Location Address: 2351 THOMAS STREET, HOLLYWOOD, FL 33020
Lot(s): 10 W 7.75, 11,12 Block(s): 37 Subdivision: HOLLYWOOD PARK
Folio Number(s): 5142 09 05 6120

TO THE CITY OF HOLLYWOOD
DEVELOPMENT SERVICES - PLANNING DIVISION
TECHNICAL ADVISORY COMMITTEE REPORT – RESPONSE LETTER
COMMENTS AND **ANSWERS IN RED**

SUBJECT: Preliminary Site Plan and Design review for 18 Residential Units.

C7

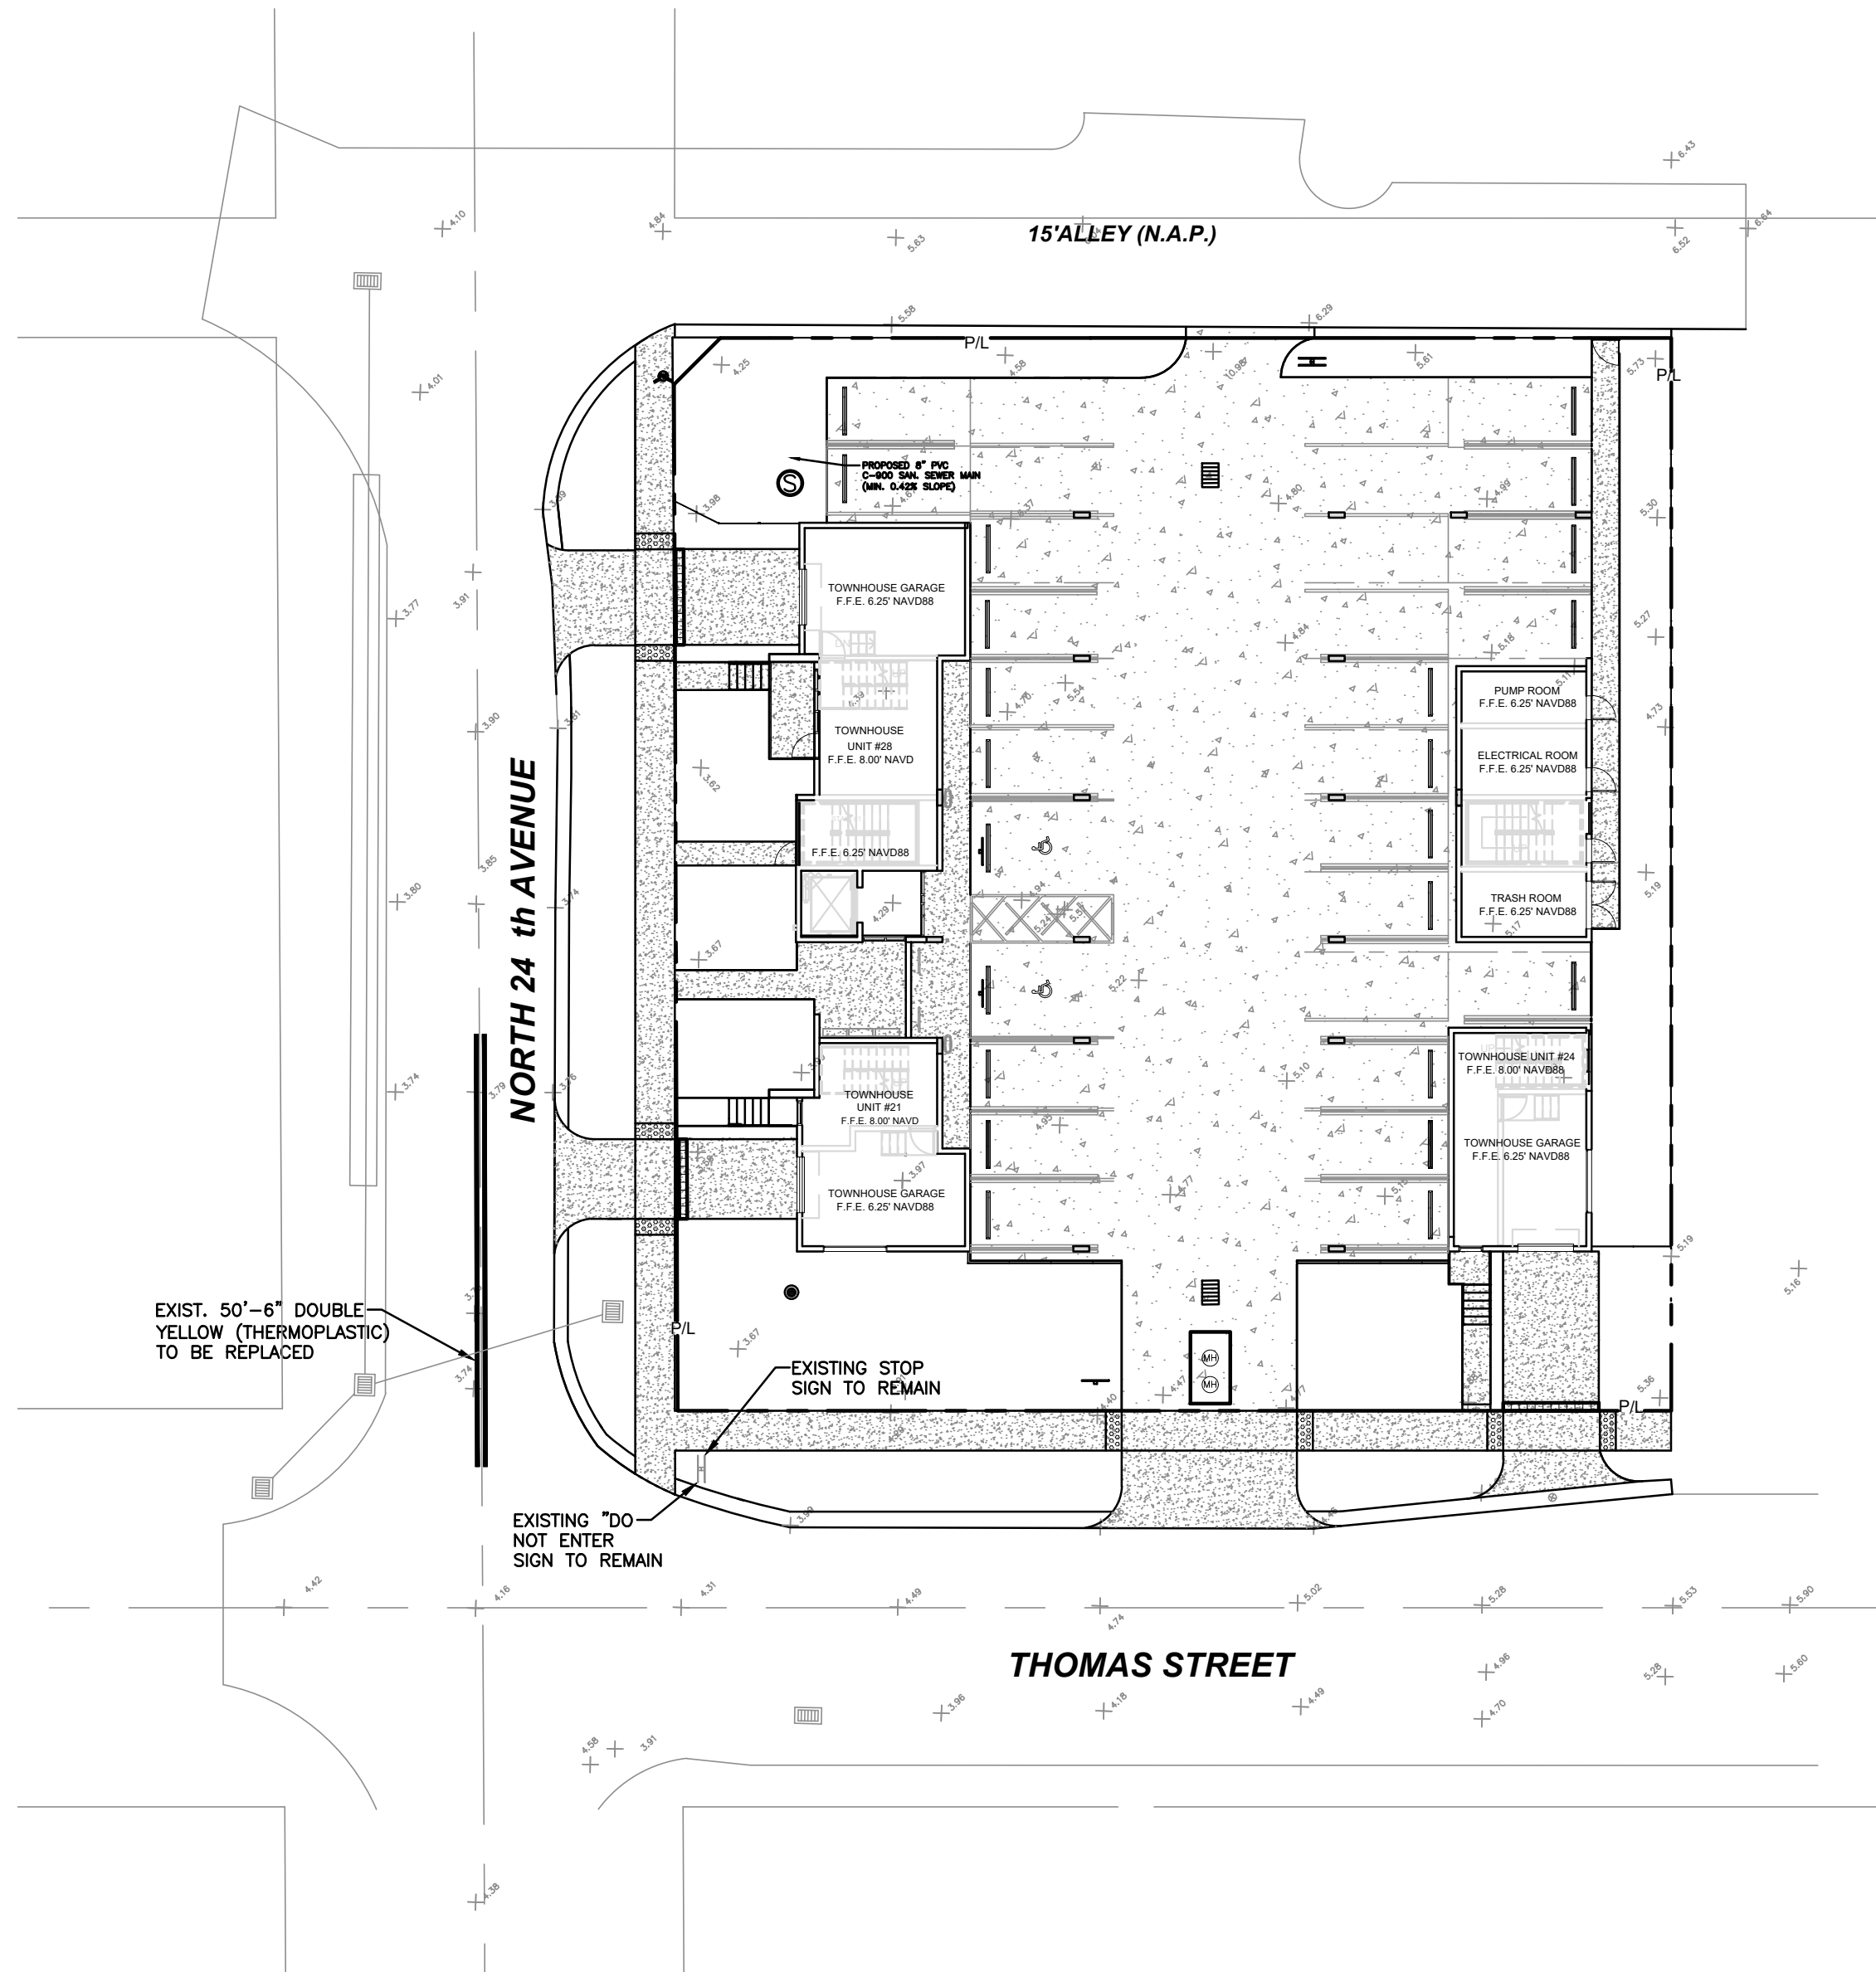
31. On civil plans, indicate items such as but not limited to drainage improvements, curbing, drive aisle widths, vehicular circulation, sight visibility triangle, vehicular turning radio, pavement marking and signage plans and details. Show location of existing water and sewer mains on plans and show the project is planning to connect to the city system. For water and sanitary sewer connection, show any pavement restoration and details required for connections within City rights-of-way. Full road width asphalt pavement mill and resurface is required for all adjacent road / alley to the parcel. Provide City of Hollywood pavement, sidewalks and swale grading details in plan set. **R. SEE CIVIL PLANS SHEETS C-2, C-5, C-6 & C-7.**
